UNITED STATES PATENT AND TRADEMARK OFFICE

Office Action Summary	Application No. 10/540,931	Applicant(s) SABANDO ET AL.	
	Examiner FANNIE KEE	Art Unit 3679

DETAILED ACTION

FIG. 25(C)

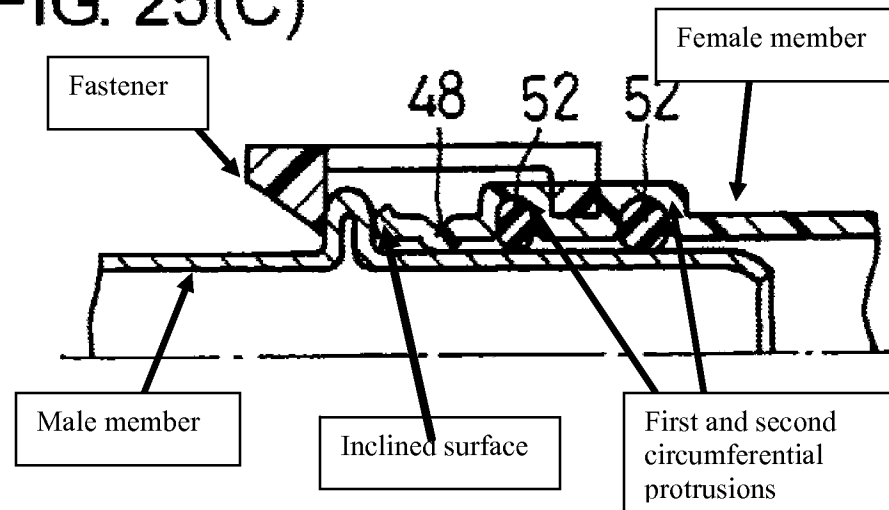
With regard to claim 3, and as shown in Figure 25(C) below, Kawasaki et al disclose a quick connecting device for ducts in motor vehicles, comprising of:

first and second sealing members (52, 52) disposed between said first and second circumferential protrusions, respectively, of said female member and said outer surface of said male member; and

a fastening member disposed around said female and male members so as to be in direct contact with the first circumferential protrusion in a manner that compresses the first sealing member, the fastening member thereby holding said female and male members axially in place.

However, Kawasaki et al do not disclose that the outer surface of the male member has a circumferential groove wherein said male member is receivable in said female member at said first end of said female member without said first end of said female member covering said circumferential groove. However, it is well known in the art to add a bead to a pipe to form a groove or a stop against which a fastener can rest. Kawasaki et al teach, in a different embodiment as shown in Figure 26, that a bead (48) can be formed on the pipe to form a groove between the bead and the upset of the pipe.

It would have been obvious to one of ordinary skill in the art at the time the invention was made to have formed a bead in a male pipe such that a circumferential groove is formed between the bead and upset of the male pipe wherein when the male member is received in the female member at the first end of the female member, the first end of the female member does not cover the circumferential groove because it is well known in the art to add a bead to a pipe to form a groove or a stop against which a fastener can rest.

With regard to claim 7, and as shown in Figure 25(C) above, Kawasaki et al disclose a quick connecting device for ducts in motor vehicles, comprising of:

a male member having first and second opposite ends, said male member being receivable in said female member at said first end of said female member with said first and second sealing members (52, 52) respectively disposed between said first and second protrusions of said female member and said outer surface of said male member, and

a fastening member disposed around said female and male members so as to be in contact with the first circumferential protrusion in a manner that compresses the first sealing member, the fastening member thereby holding said female and male members axially in place.

However, Kawasaki et al do not disclose that the outer surface of the male member has a circumferential groove with an inclined surface leading from the circumferential groove wherein the first sealing member is located on the inclined surface and wherein said male member is receivable in said female member at said first end of said female member without said first end of said female member covering said circumferential groove. However, it is well known in the art to add a bead to a pipe to form a groove or a stop against which a fastener can rest. Kawasaki et al teach, in a different embodiment as shown in Figure 26, that a bead (48) can be formed on the pipe to form a groove between the bead and the upset of the pipe. Kawasaki et al also show in Figure 25(C) that there is an inclined surface leading from the circumferential groove (side of upset of male member) where the male and female members can be shortened such that the first sealing member can rest against the inclined surface of the circumferential groove of the male member.

It would have been obvious to one of ordinary skill in the art at the time the invention was made to have formed a bead in a male pipe such that a circumferential groove is formed between the bead and upset of the male pipe wherein when the male member is received in the female member at the first end of the female member, the first end of the female member does

not cover the circumferential groove because it is well known in the art to add a bead to a pipe to form a groove or a stop against which a fastener can rest and to have shortened the length of the male and female members such that the first sealing member can rest against the inclined surface of the circumferential groove of the male member because the optimization of proportions in a prior art device is a design consideration within the skill of the art. In re Reese, 290 F.2d 839, 129 USPQ 402 (CCPA 1961).
